ADDENDUM NO. 1

LIBERTY AND WESTCHESTER INTERMEDIATE SCHOOLS - ATHLETIC SITE PROJECTS Chesterton, IN 46304

ADDENDUM ONE

Addendum One (AD.01) to the drawings and specifications prepared by Gibraltar Design for **Liberty and Westchester Intermediate Schools Athletic Site Projects** for Duneland School Corporation, Chesterton, Indiana.

C-3.3

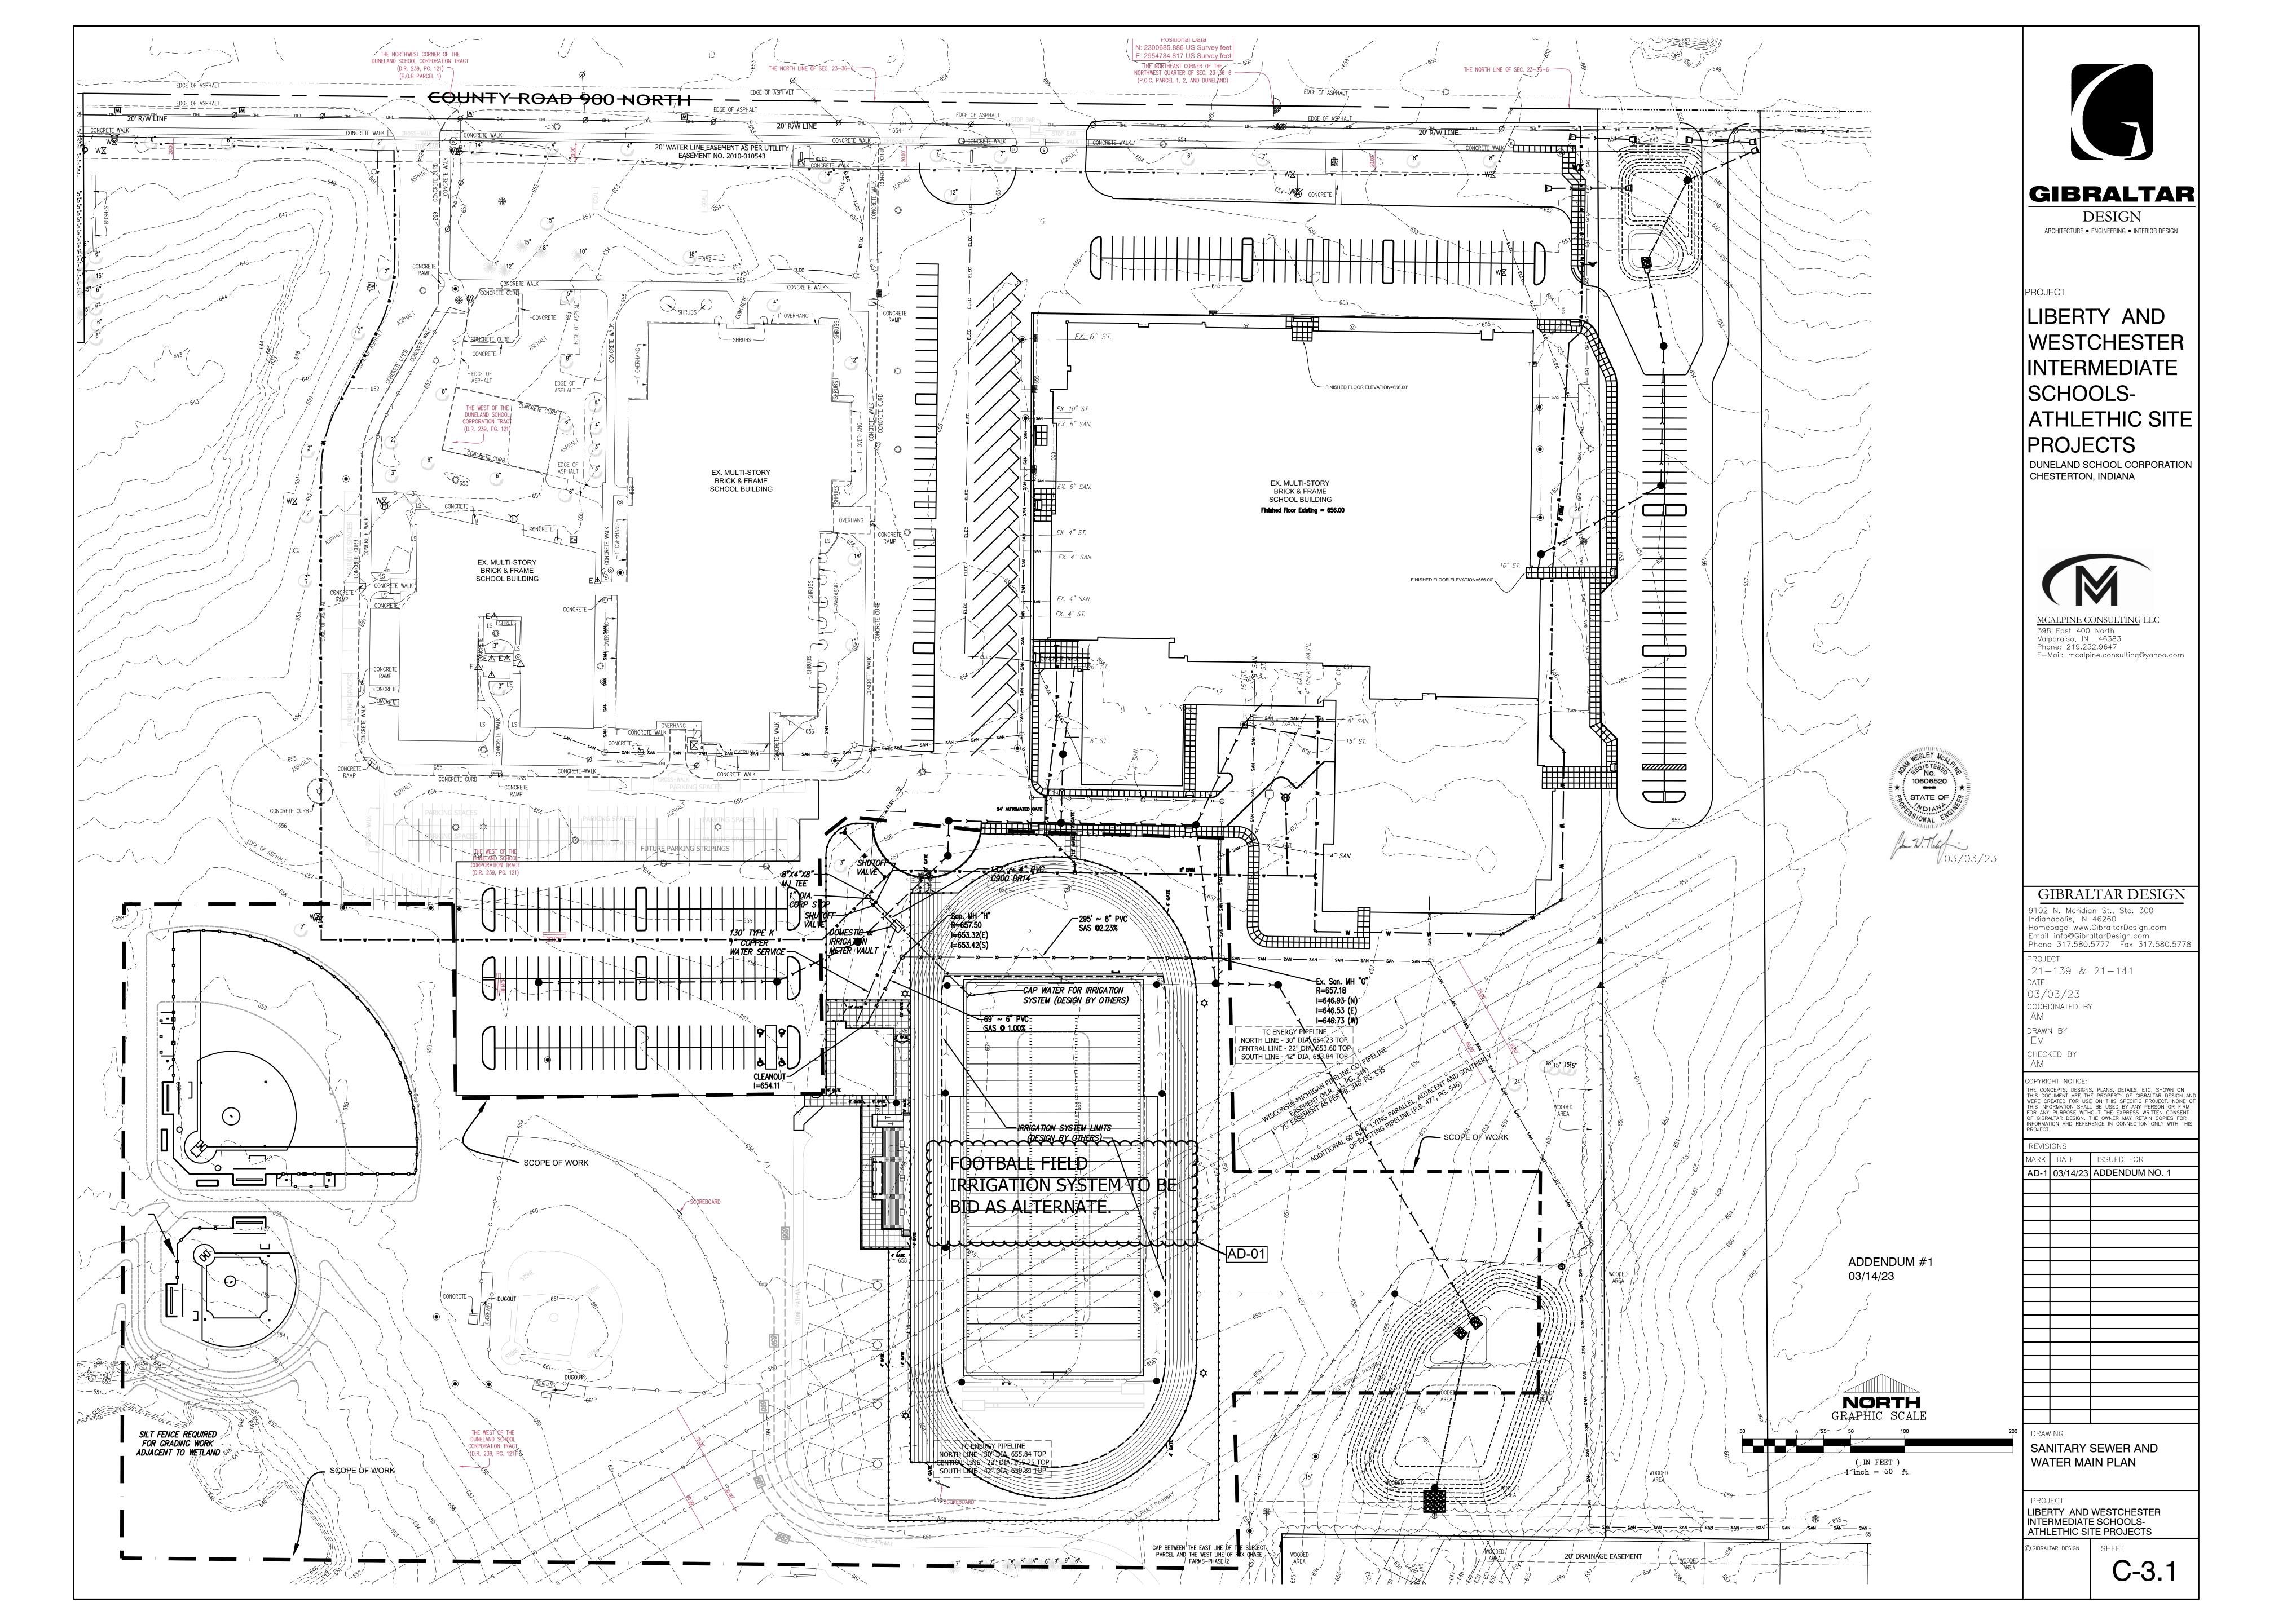
3. Sheets C-3.1 and C-3.3

- A. Refer to two (2) revised full-size drawings, included in this Addendum, for the following revisions:
 - 1. Add the following note to football field: "Football field irrigation system to be bid as Alternate."

S-101 LIS

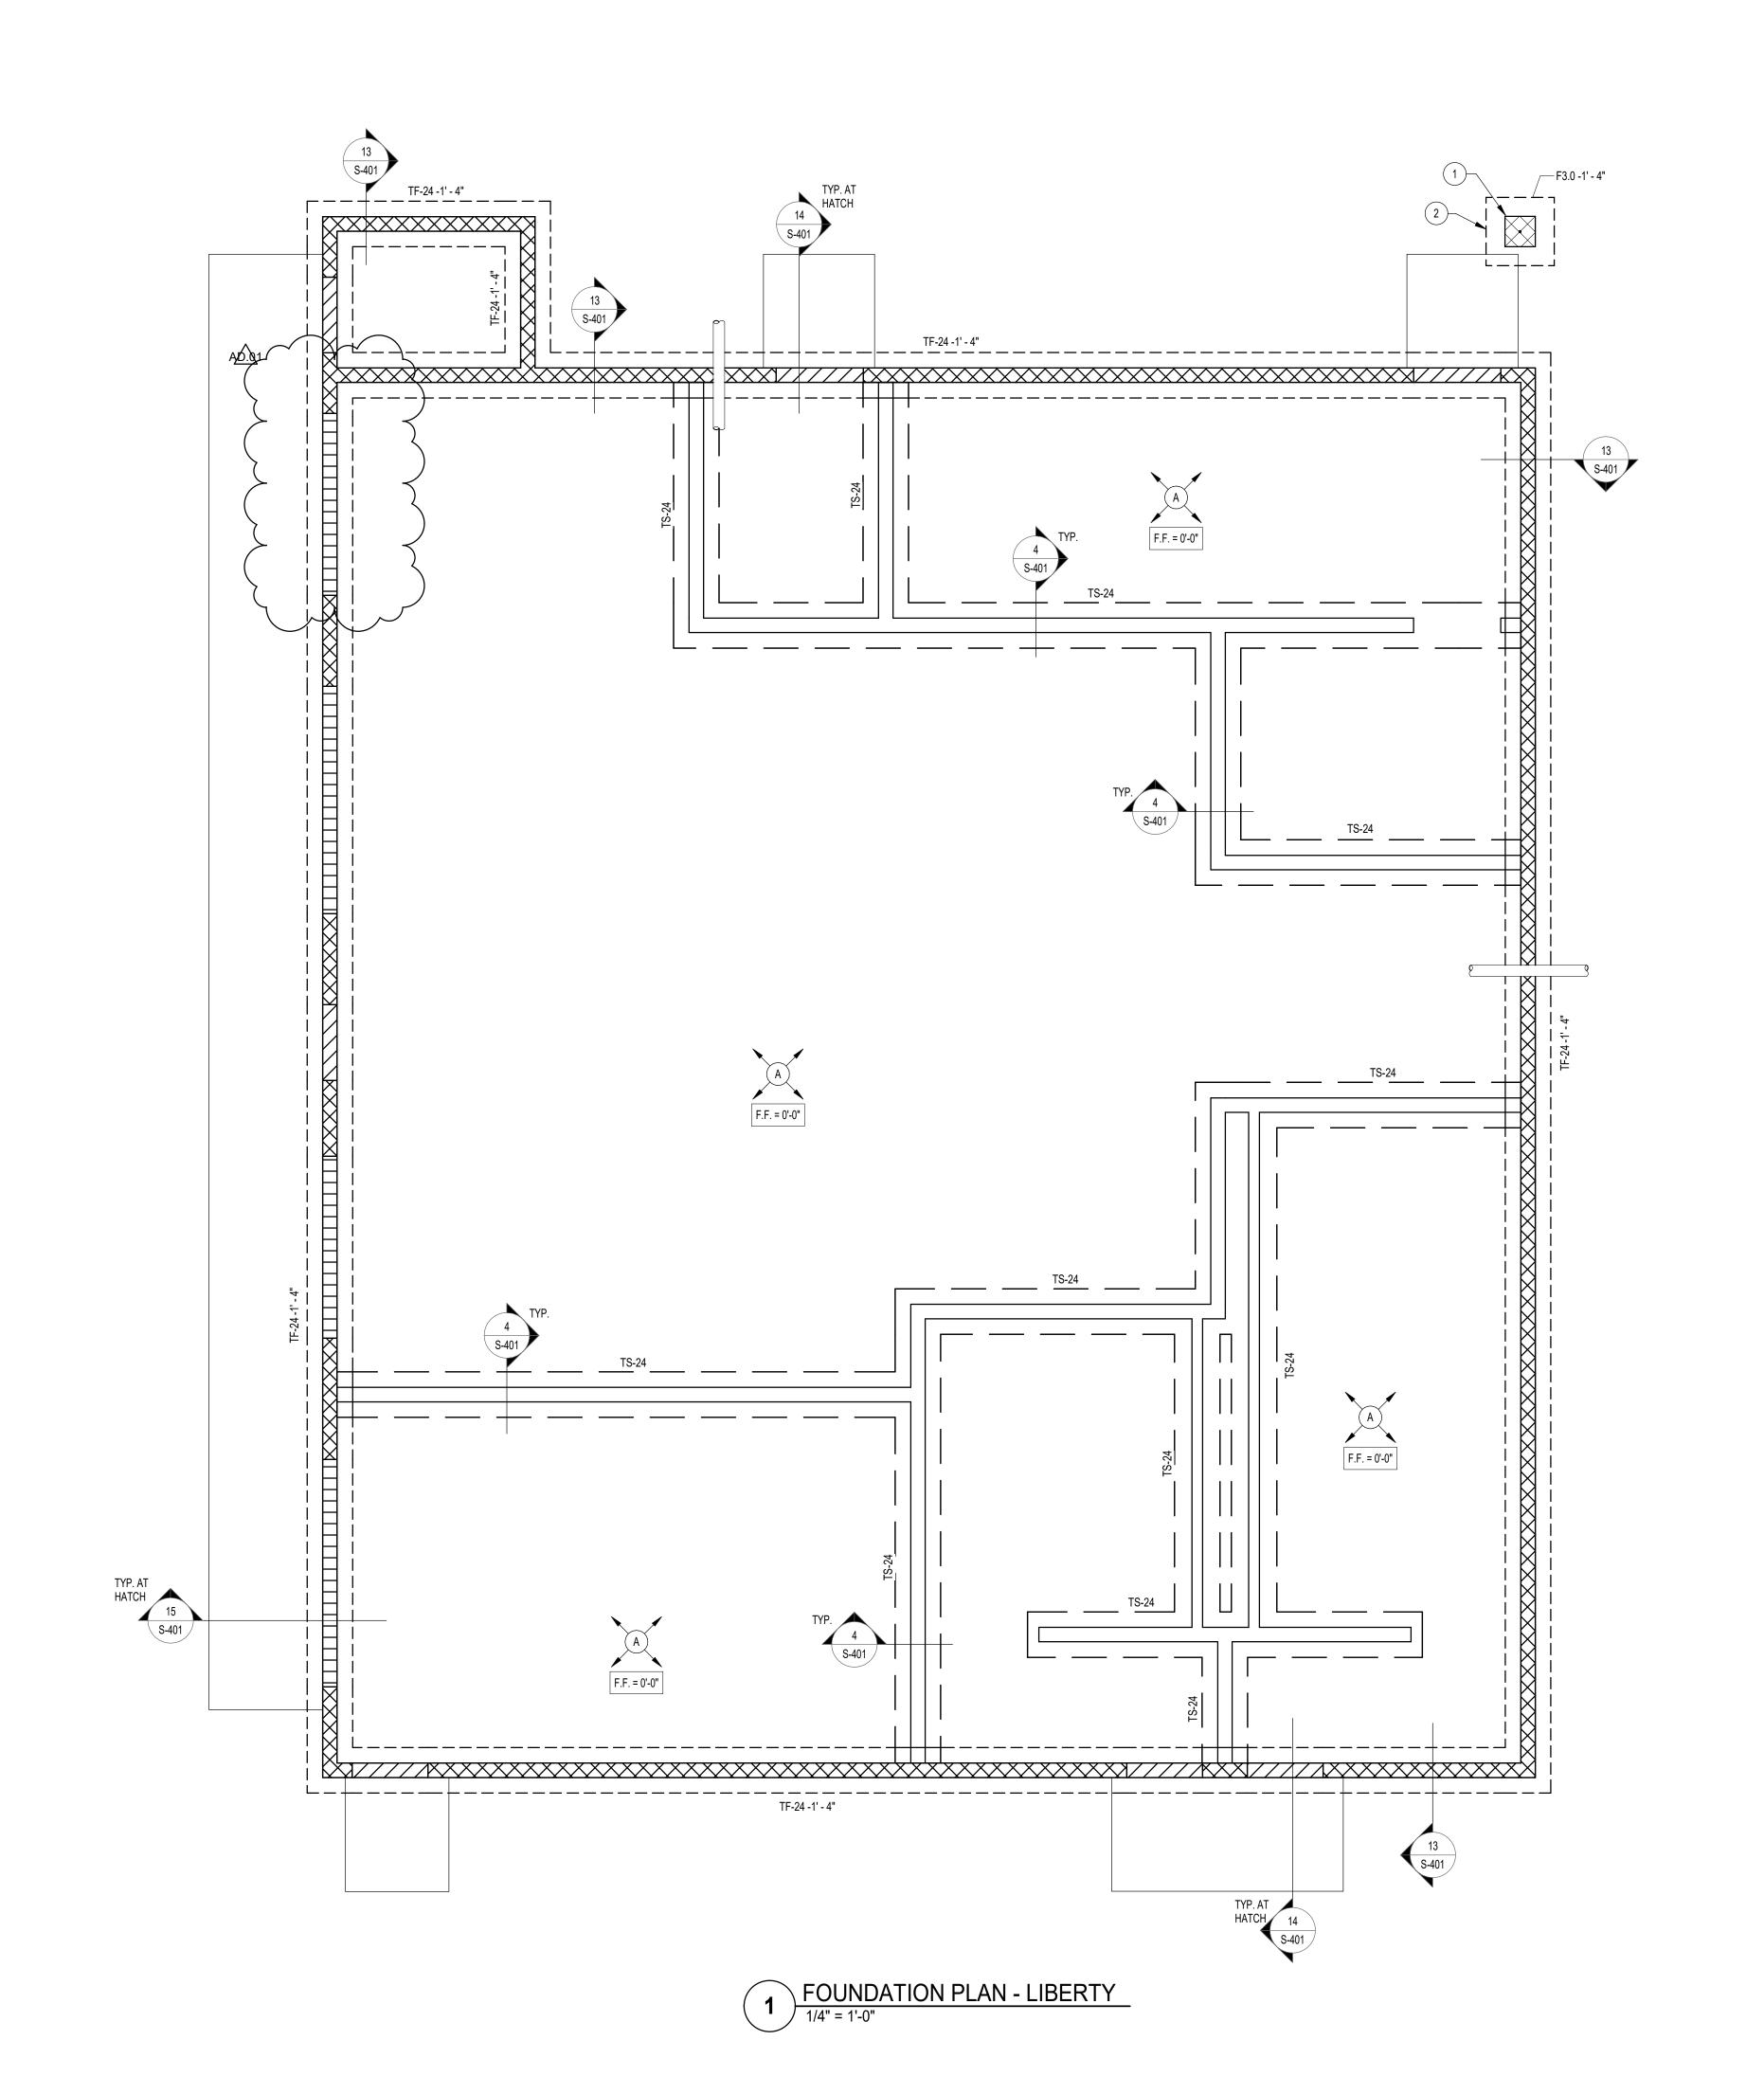
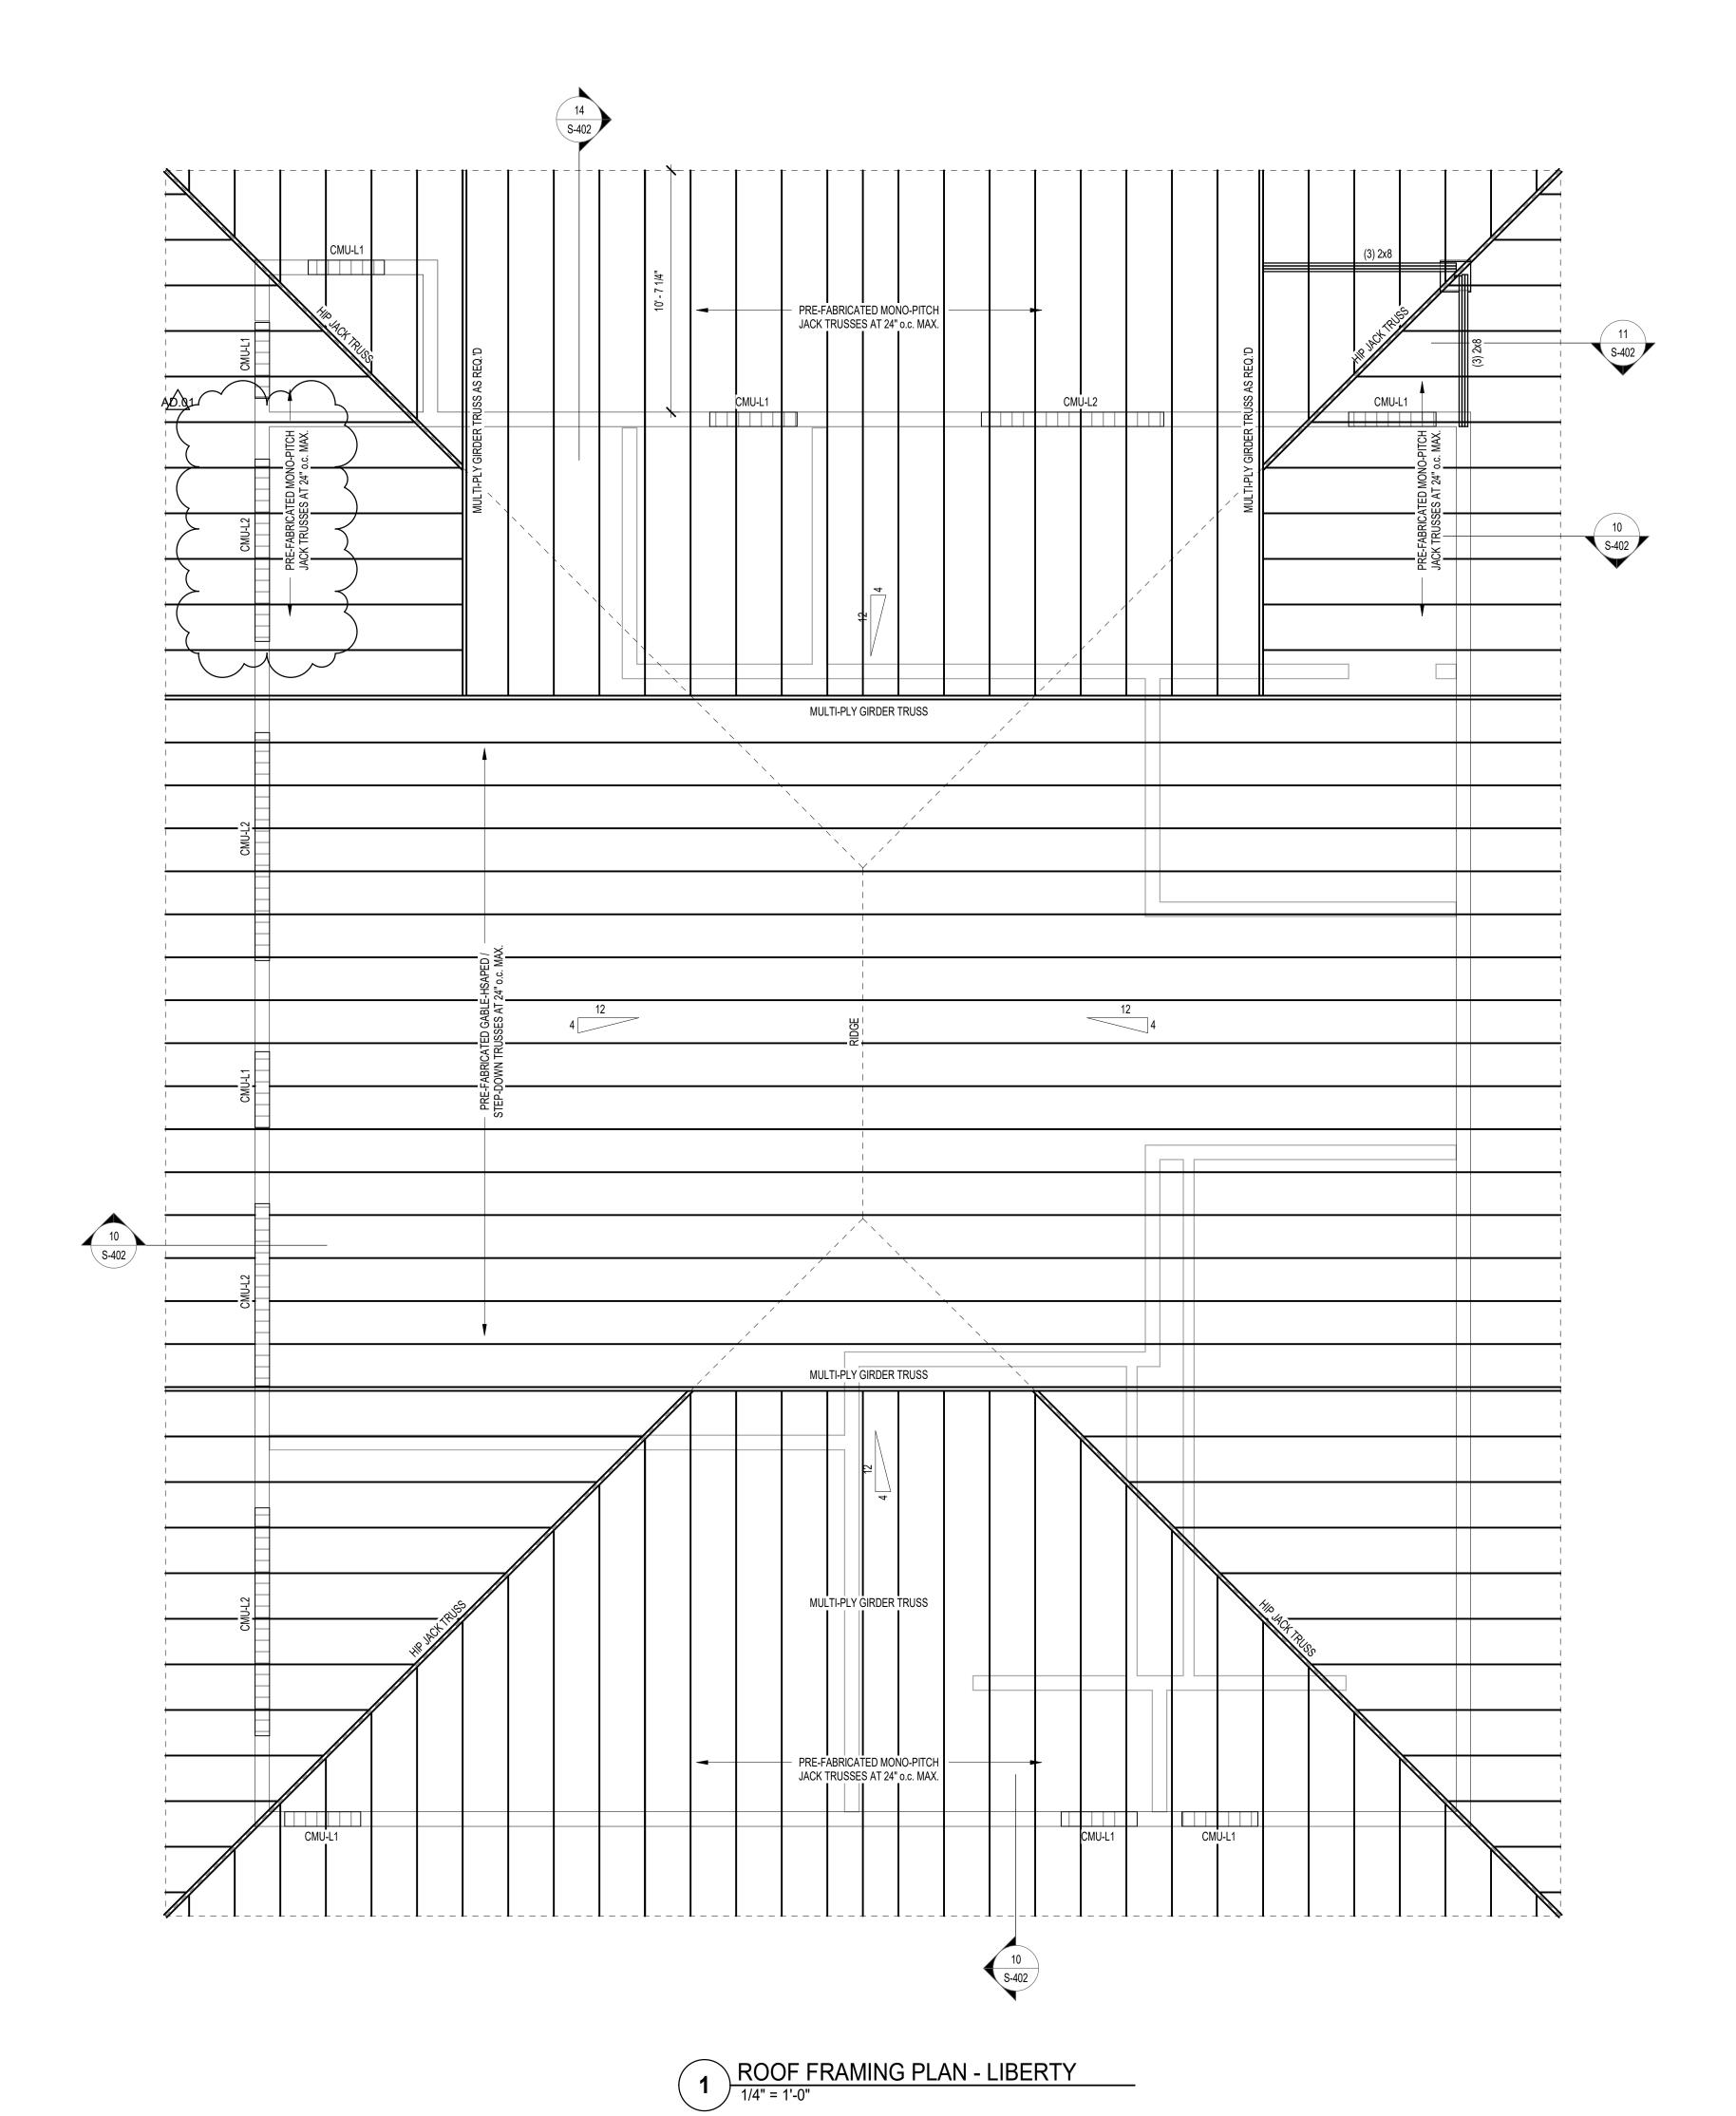
4. Sheet S-101 LIS and S-103 LIS

A. Refer to two (2) revised full-size drawings, included in this Addendum, for revisions.
